SOLICITATION AMENDMENT MODIFICATION DE L'INVITATION

Title - Sujet CAT 1-6 Translation Bureau	
Solicitation No. - N° de l'invitation EP916-212024/A	Amendment No. - N° modif. 003
Client Reference No. - N° de référence du client 20212024	Date 2021-02-17
GETS Reference No. - N° de référence de SEAG PW-\$\$\$PQ-998-79682	
File No. - N° de dossier pq998.EP916-212024	CCC No./N° CCC - FMS No./N° VME
Solicitation Closes - L'invitation prend fin at - à 02:00 PM Eastern Standard Time EST on - le 2021-02-24 Heure Normale du l'Est HNE	
F.O.B. - F.A.B. Plant-Usine: <input type="checkbox"/> Destination: <input checked="" type="checkbox"/> Other-Autre: <input type="checkbox"/>	
Address Enquiries to: - Adresser toutes questions à: Bouvier, Patrick	Buyer Id - Id de l'acheteur pq998
Telephone No. - N° de téléphone (819) 360-2596 ()	FAX No. - N° de FAX () -
Destination - of Goods, Services, and Construction: Destination - des biens, services et construction:

Amendment 003 is raised to publish questions and answers:

Workstation Panel and Furniture Layout

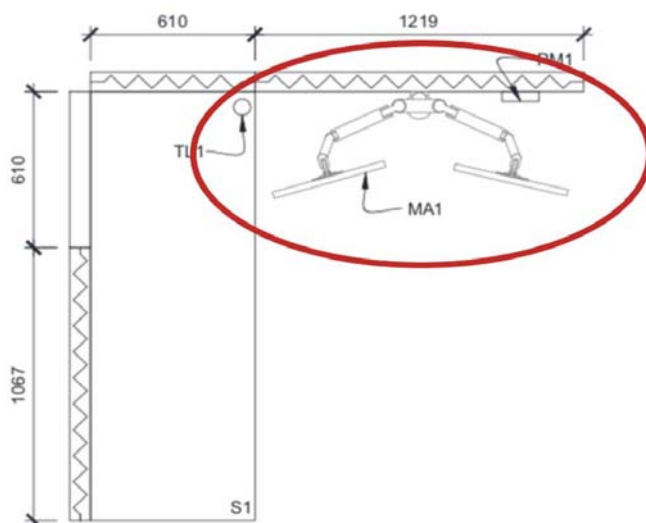
Q33. Category 1A, in file 1.0 FURNITURE DATA SHEETS: 1.2 Typical Workstation B:

Is it accepted to put the second duplex of P7 in P8 for Typ. B?

A33. No, this will not be accepted as an option. Additional outlet can be moved to Panel P6..

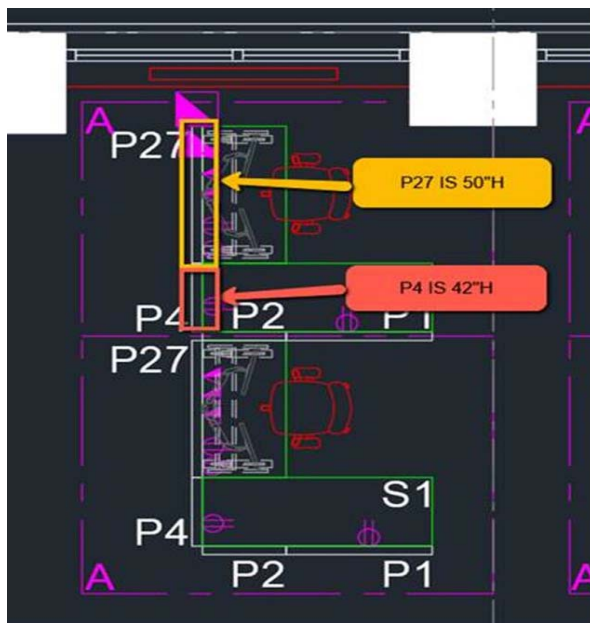
Q36. Category 6C: Line 6 - C6 tables and Line 8 - C8 chairs Chairs are requested between 5 PM and 8 PM but the table is 34 to 37"H. Should we instead provide 36"H surface stools or a 29"H table?

A36. Provide 29 in. table.
